**Advisory Committee on Reactor Safeguards (ACRS)  
License Renewal Subcommittee  
Seabrook Station, Unit 1 (Seabrook)**

**Safety Evaluation Report (SER)  
with Open Items**

Arthur Cunanan, Project Manager  
Office of Nuclear Reactor Regulation

# ASR at Seabrook Electrical Tunnel

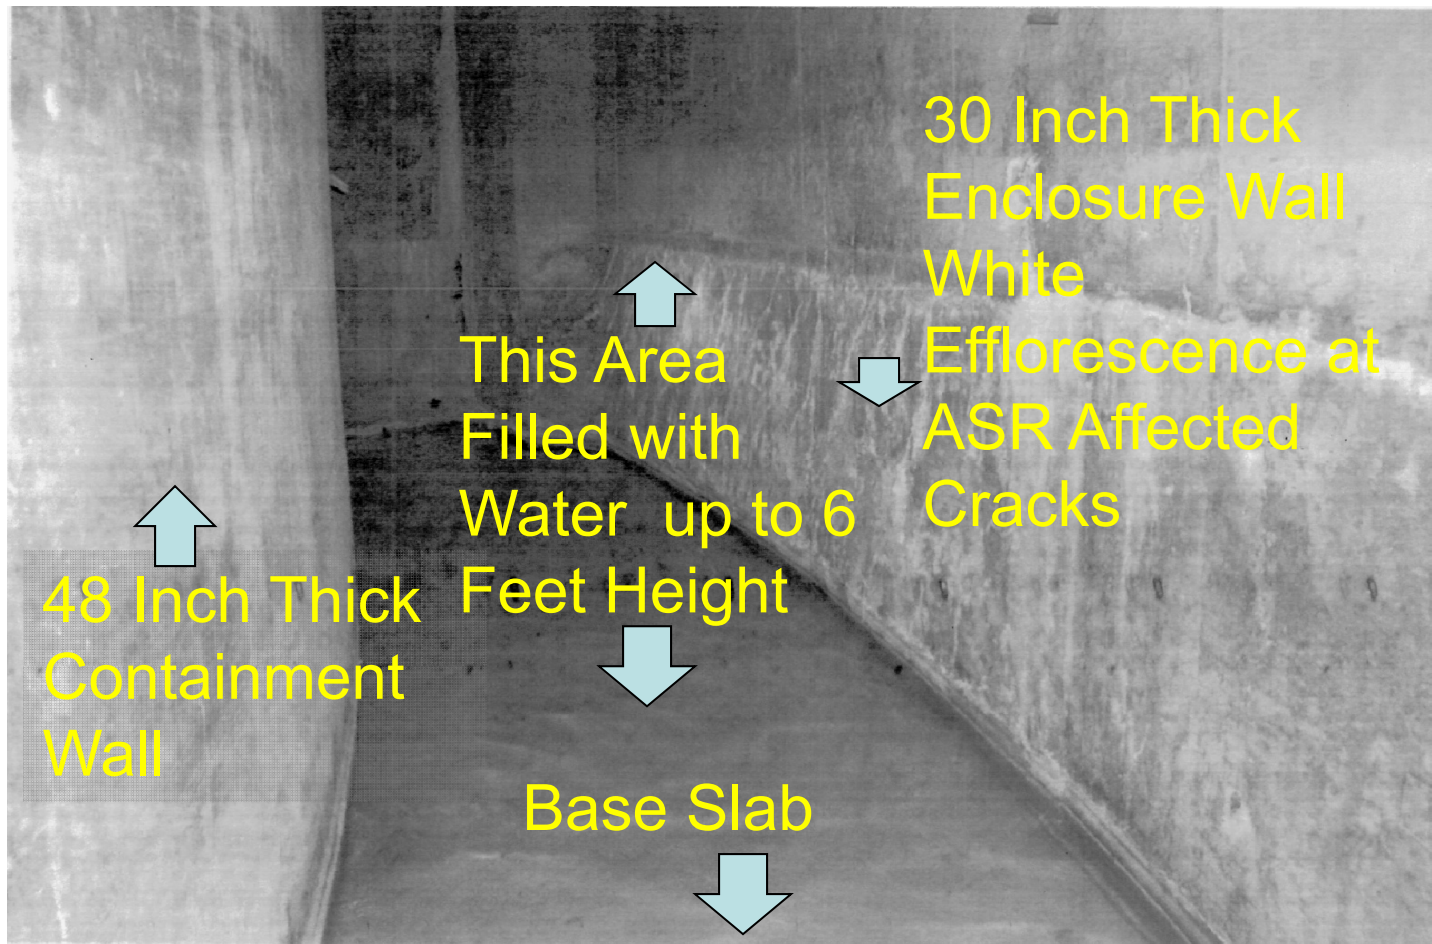
- Applicant observed cracking at two locations
  - Crack width no more than 8 mils
- Cracking pattern observed is indicative of ASR
- The applicant considers 8 mils maximum crack width insignificant
  - Cracks due to ASR grow over time
  - 15 mil crack width criteria is for passive cracks
  - GALL report and related industry standards require further evaluation of active cracks
- Absence of ASR can only be confirmed by petrographic examination of core samples
- The applicant has not addressed the long term effects of ASR on degradation of mechanical properties of concrete
- The applicant has not enhanced the containment IWL program for ASR
